COUNTY COUNCIL'S RESPONSE TO CONSULTATION ON THE FOLLOWING DEVELOPMENT PROPOSAL

Application no: 19/01047/OUT

Proposal: Outline planning application for a residential development of up to 850 dwellings; green infrastructure including formal (playing fields with changing rooms, allotments) and informal open space, landscaping; and associated infrastructure including a balancing pond; on land off the A4260, with access off the existing Longford Park access off the A4260 (Oxford Road), and a new access off the A4260 (Banbury Road). All matters of detail reserved, save for access.

Location: Land North East Of Oxford Road West Of Oxford Canal And East Of Bankside Banbury

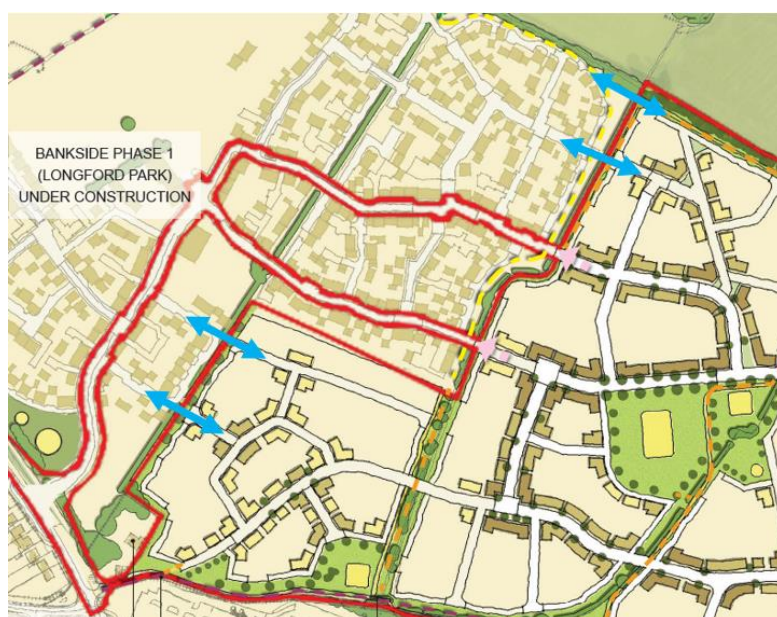
Internally, the Longford Park Road / Hobby Road / Songthrush Road crossroad junction does not provide priority for any arm and there are no formal crossing points despite its proximity to a primary school. The county council considers that the crossroad is not fit for the use of an additional 450 dwellings and construction traffic without necessary alterations including prioritisation and crossing facilities. Without this, the increase in traffic movements at this junction in conjunction with the lack of proper crossing facilities for the nearby primary school could have a severe impact on highway traffic and safety. It is also noted that none of the internal junctions have had capacity assessments.

Suitability of Songthrush / Hobby Road for additional traffic – These roads are not suitable for any significant increase in through traffic that would result from an additional 450 dwellings and associated construction HGVs. These two roads have been designed according to Manual for Streets standards to cater for residential development. As such they have traffic calming features that make them suitable for light residential traffic only. The junction between Songthrush / Swift Drive / Hobby Road is of concern as its layout is not suitable for a bus route and therefore significant through traffic and HGV flow could result in highway safety issues. It should be noted that the capacity of this road for significant traffic flow and HGVs could also be limited by ad-hoc on-street parking as there are no parking controls in place. Policy TR7 (saved policy of adopted 1996 local plan) states that: “Development that would regularly attract large commercial vehicles or large numbers of cars onto unsuitable minor roads will not normally be permitted.”

For the above reasons, the county council believes that the delayed provision of the second access to the south of the site will have an unacceptable impact on highway safety and refers to policy TR1 (saved policy of adopted 1996 local plan) which states that “before proposals for development are permitted the council will require to be satisfied that new highways, highway improvement works, traffic management measures, additional public transport facilities or other transport measures that would be required as a consequence of allowing the development to proceed will be provided.” As such, we are strongly opposed to the delayed provision of the southern access to the site until the completion of 450 homes and consider that the southern access junction and spine road must be delivered at an early phase of the development as required for direct mitigation.

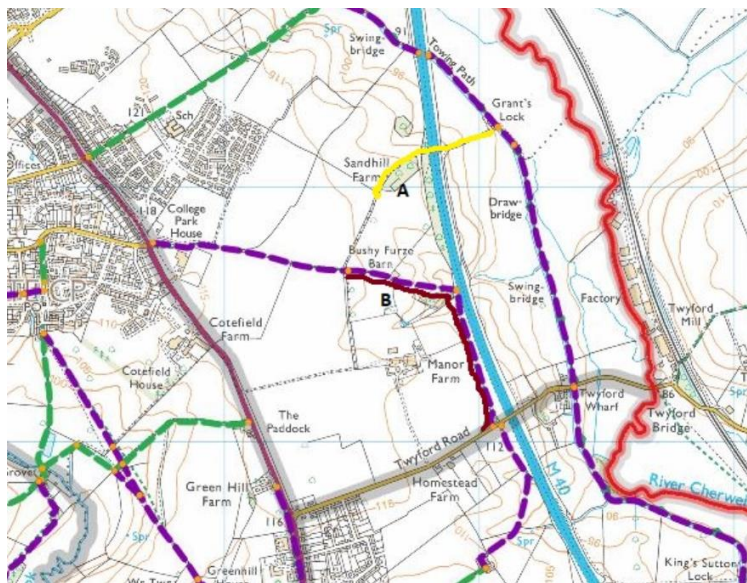
Roads to be used by buses need to be tracked for a standard 12 metre vehicle. Buses must be able to progress around the development at a steady rate, and not blocked by parked cars. This must also be the case for the existing roads through the Phase 1 development and it is noted that these roads are included within the redline boundary of the development site.

Whilst there are few dwellings along the southern section of the new access road, adequate physical provision must be made for service and school buses adjacent to the proposed secondary school site. Car movements associated with the school (for example drop-offs) must be made away from the spine road and the spine road must be signed and lined to resist such activity.
